Vogtle Electric Generating Plant- Units 1&2  
Systematic Risk-Informed Assessment of Debris Technical Report SNC Response to  
NRC Request for Additional Information (RAIs #11-14)

**Vogtle Electric Generating Plant Unit 1 and 2**

**SNC Response to NRC Request for Additional Information (RAIs)**

**Figure 11-1: Example of weld that does not monotonically increase with break size**

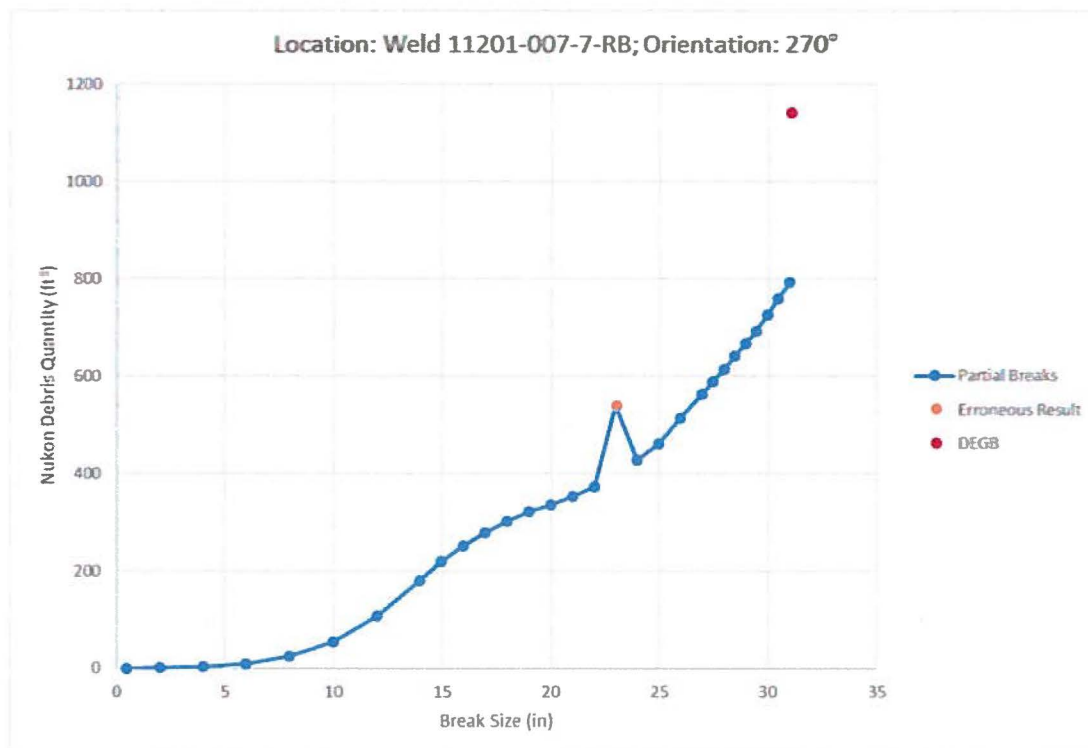
When the BADGER results database for Vogtle was evaluated in more detail, it was discovered that in some cases the debris quantity does not always monotonically increase with break size (see example in Figure 11-1).

For a given break location and break orientation, it is not physically possible for a larger break to have a smaller debris quantity. Therefore, this is an erroneous result in the calculation.

The potentially significant erroneous results for the 47 ZOIs were corrected in a modified BADGER database by conservatively using the debris quantity for the next larger break size at

the same location and orientation. A sensitivity case was run in NARWHAL, which showed that the variations for these debris quantities had no effect on the conditional failure probabilities.

**Figure 12-1: Maximum fiber on the RHR Strainer**

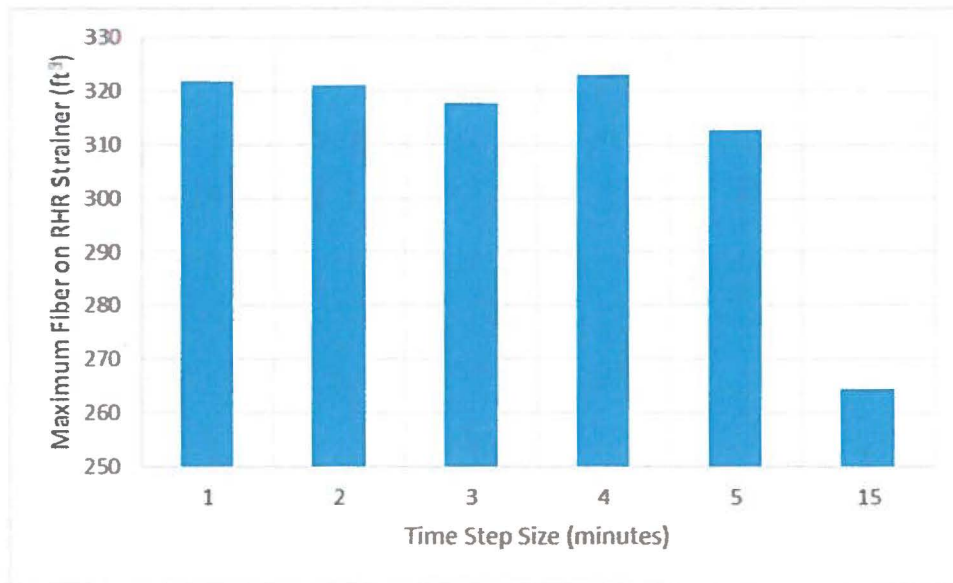
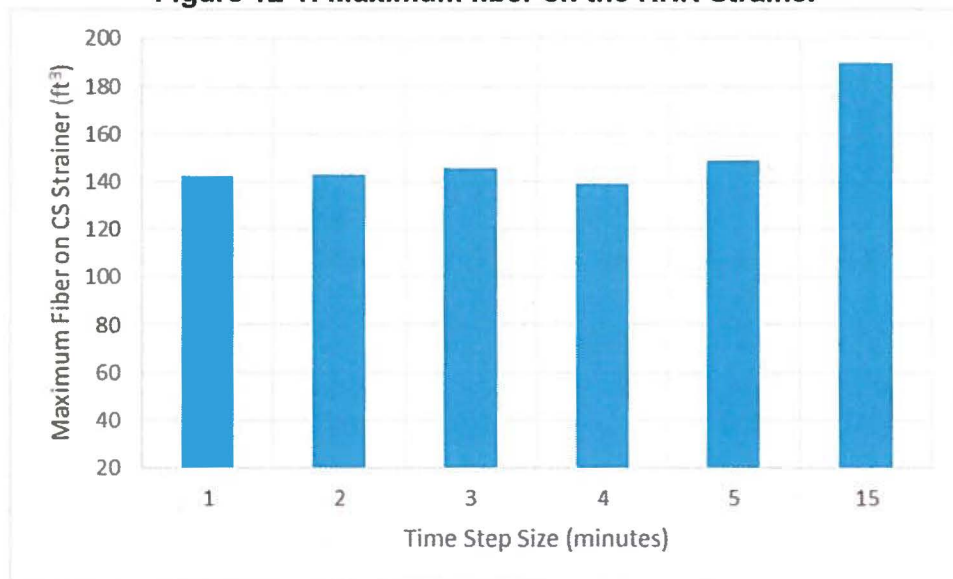
The following figures show the results from the equipment configuration with all pumps running for the break that results in the most fiber on the RHR strainer (DEGB at weld 11201-004-6-RB on the hot leg in Loop 4). Figure 12-1 and Figure 12-2 show the fiber accumulation on the RHR and CS strainers. As shown, the results have very little variability for the smaller time-step sizes, but are significantly different for the 15-minute time-step size.

The overall conclusion from the NARWHAL sensitivities (with larger time-step sizes) and comparisons to hand calculations (with smaller time-step sizes) is that a one-minute time-step size for the first 24 hours is small enough to sufficiently capture the transient GSI-191 phenomena and accurately quantify the risk associated with GSI-191.

**Figure 12-3: Maximum Fiber in the Reactor Vessel**

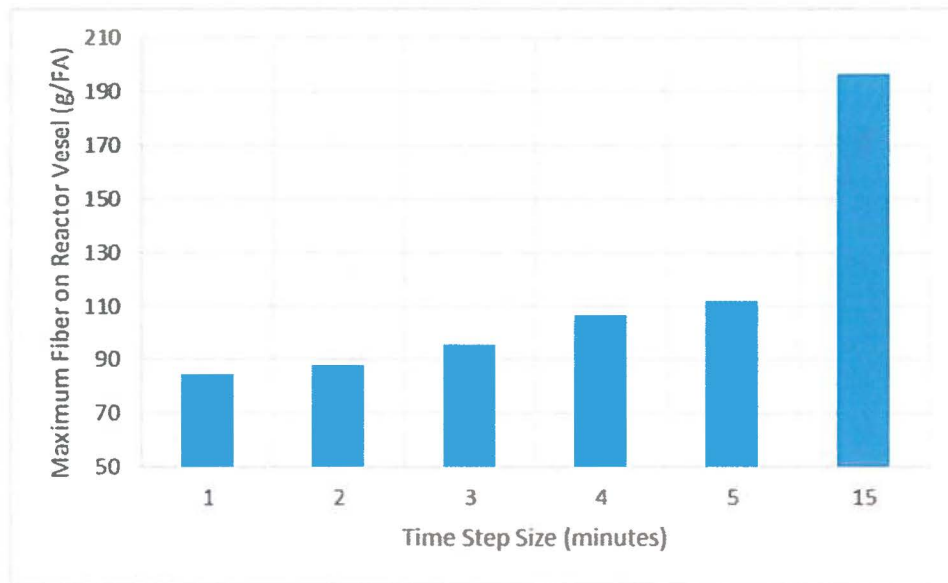
Figure 12-3 shows the maximum quantity of fiber in the reactor vessel as a function of time-step size. There is a definitive trend in this figure, where larger time-step sizes result in more fiber accumulation in the reactor vessel. This indicates that the penetration/shedding models are more sensitive to larger time-step sizes, which is consistent with the hand calculation sensitivity results discussed previously.

**Figure 12-4: Maximum SAS on RHR Strainer**

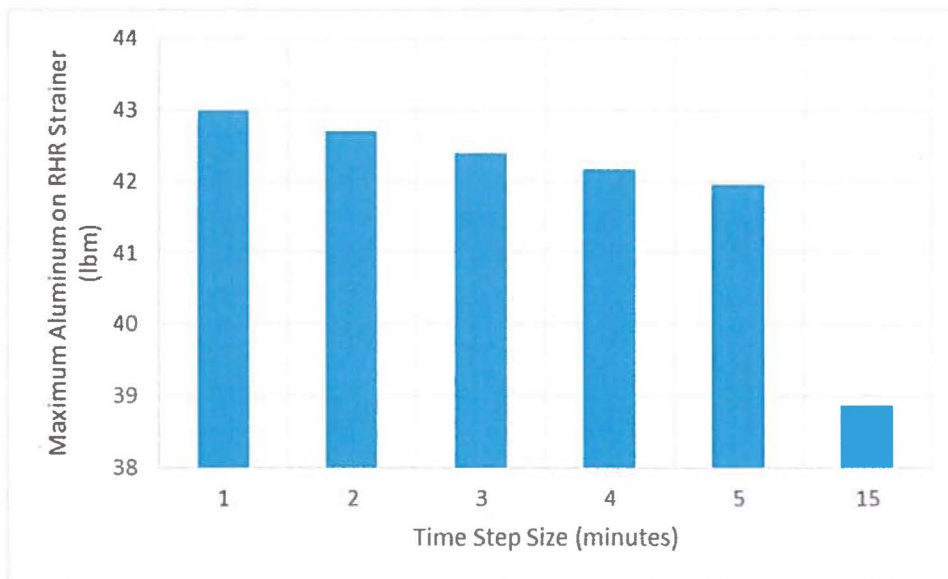
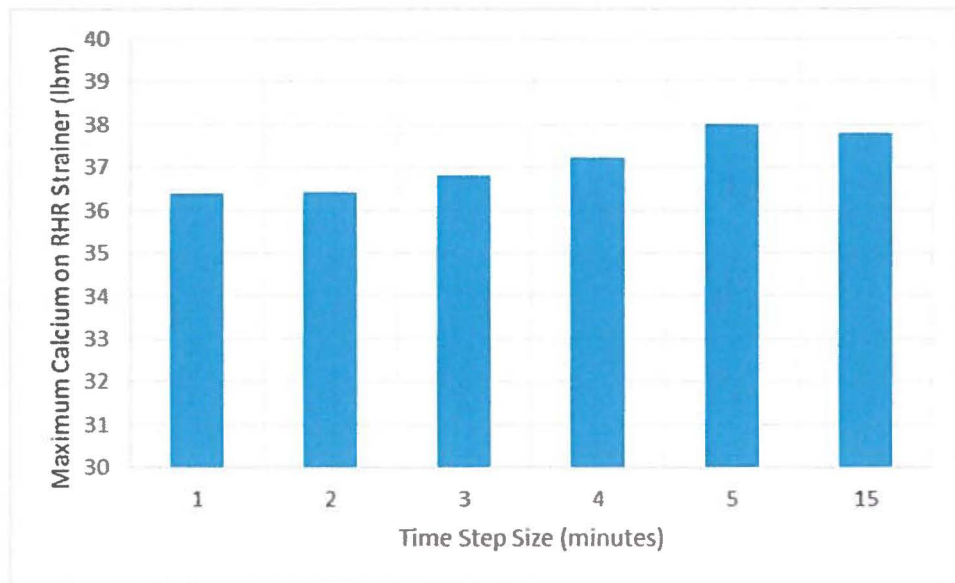
Figure 12-4 and Figure 12-5 show the sodium aluminum silicate and calcium phosphate on the RHR strainer as a function of time-step size. As shown, the aluminum has a decreasing trend with increasing time-step size, and the calcium has an opposite trend.
